MEMORANDUM

From:	Tina Cuss Ecology Officer	To (Case Officer):	Marcus Watts
Service	WBC Ecology	App No:	251233
Address:	Warren Crest Farm, Wick Hill Lane, Finchampstead, Wokingham, RG40 3PY.		
Type of Development:	Minor Dwellings (1-9)		
Proposal:	Full application for the proposed erection of 3no. dwellings following demolition of existing dwelling, outbuilding and agricultural barns.		
Site Visit Made:	No

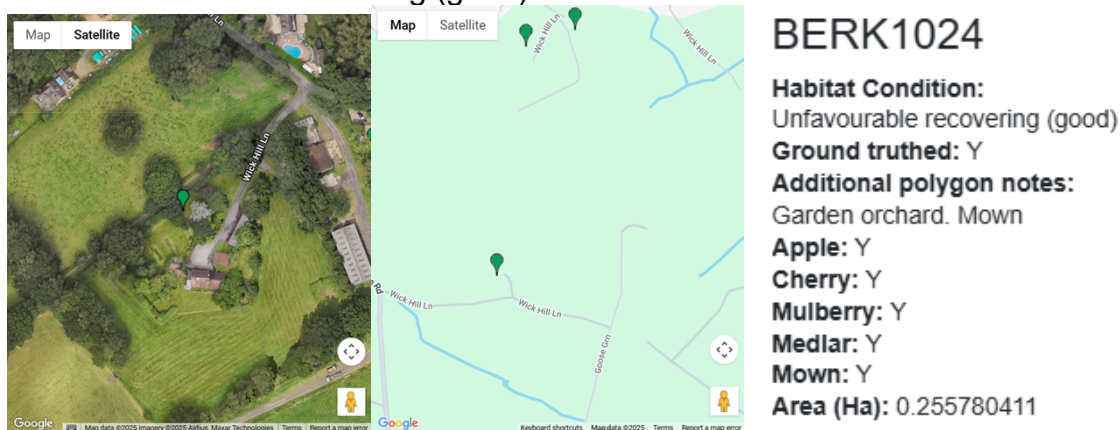
In order to agree the baseline, more information and a clearer Baseline Habitats map is needed to assess whether habitat estimated as lost in Table 5.1, and if the metric is accurate. According to the Site Plan, it appears that less than 0.143ha of modified grassland in PR1, PR3 and PR4 would be retained. I consider it likely more of PR1, PR3, and PR4 would be maintained as private garden or is proposed to be seeded with wildflower grassland, therefore not retained. I request the Baseline Habitats Plan is revised and further annotation/explanation is given to clarify where the boundaries of each parcel are. This should include details of the parcels immediately to the south of the farmhouse, and to the east of B3. Can the Ecologist please clarify on the map, and metric user comments, if the retained 0.143ha of poor grassland includes P4?
